FINAL DRAINAGE PLAN AND REPORT

POENITSCH SUBDIVISION

January 16, 2019

Revised
June 18, 2019

DRAINAGE PLAN
POENITSCH SUBDIVISION

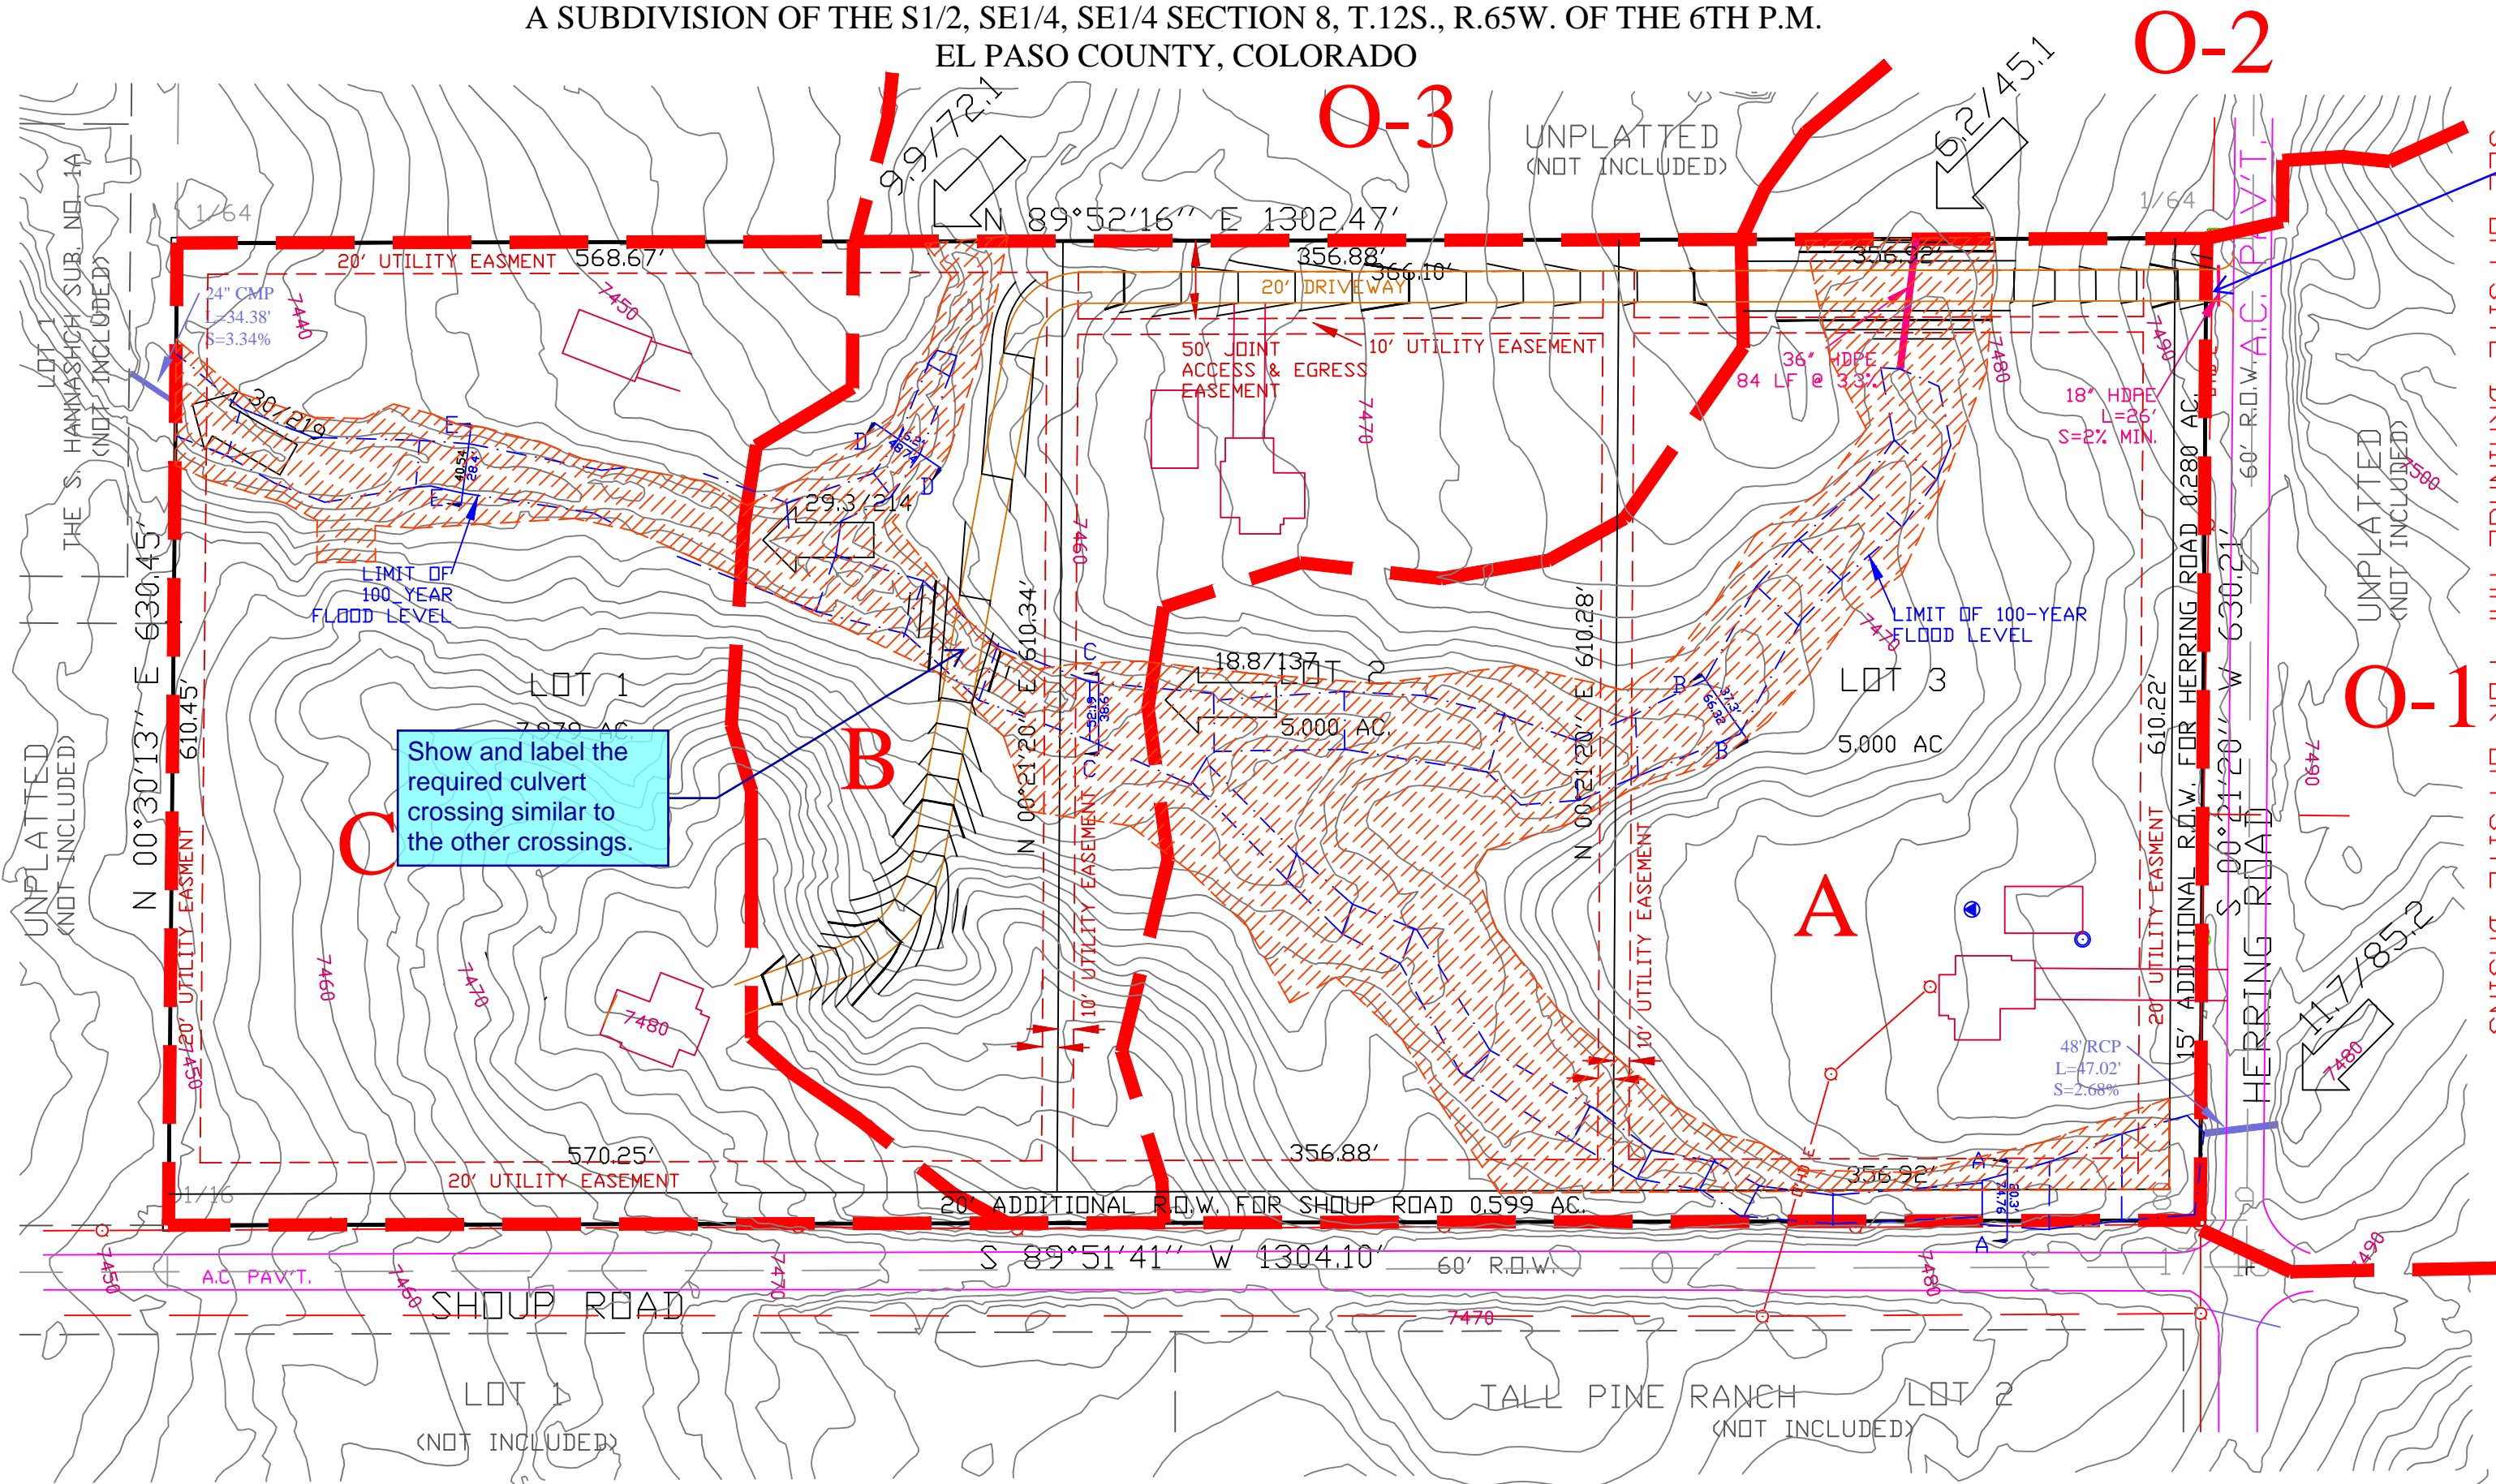
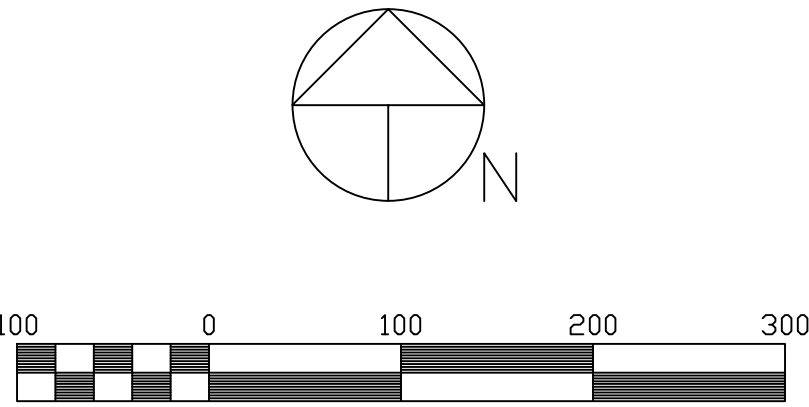
HPDE Pipe is not permitted for driveway culverts, per driveway access permit requirements. Please revise to show either CMP or reinforced concrete. Update accordingly in Cost Estimate. Unresolved.

Show and label the required culvert crossing similar to the other crossings.
